**RUSSIAN FEDERATION
MINISTRY OF TRANSPORT OF THE RUSSIAN FEDERATION
FEDERAL AIR TRANSPORT AGENCY**

AIRWORTHINESS DIRECTIVE

No. 2025-FATA-010144R-06

Applicability – ANSAT helicopters (ANSAT, ANSAT-GC models) and their modifications
Designer's State - RUSSIAN FEDERATION

Figure 202 – Examples of defects

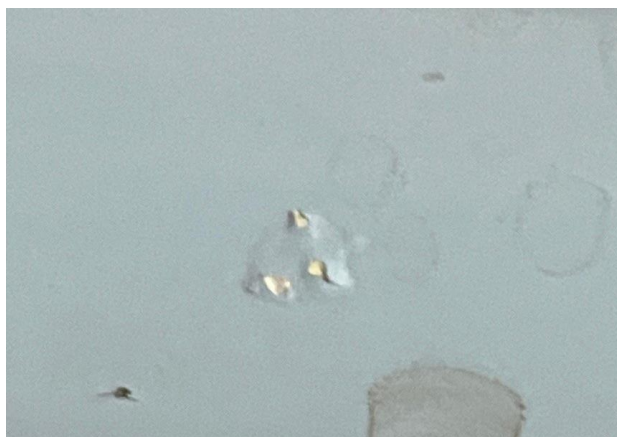
In case of detection of corrosion traces on the outer surface of XB-23 tail shaft 230-1526-000, as well as blistering (swelling) of the paint coating (see figure 202) – perform an additional inspection of the outer surface of the tail shaft for cracks and corrosion damages using IIM-15B method with the participation of the specialists of JSC “Reductor-PM”. Inspection results must be included in the Inspection report (Appendix 2).

At that, in addition to the requirements of task card 065.10.00a, introduce a restriction to prevent the presence of corrosion traces, as well as blistering (swelling) of the paint coating (see figure 202) on the outer surface of the XB-23 tail shaft.

1.2 XB-23 tail shafts 230-1526-000 with the defects detected during inspections using IIM-15B method must be removed from operation and sent for repair.

In case of detection of defects, perform an additional inspection of the tail shaft outer surface for cracks and corrosion damages using LQM-15B method with the participation of specialists of JSC “Reductor-PM” (inspection results must be included in the Inspection report according to the Appendix No. 2), in case of detection of defects – tail shaft must be removed from operation and sent for repair.
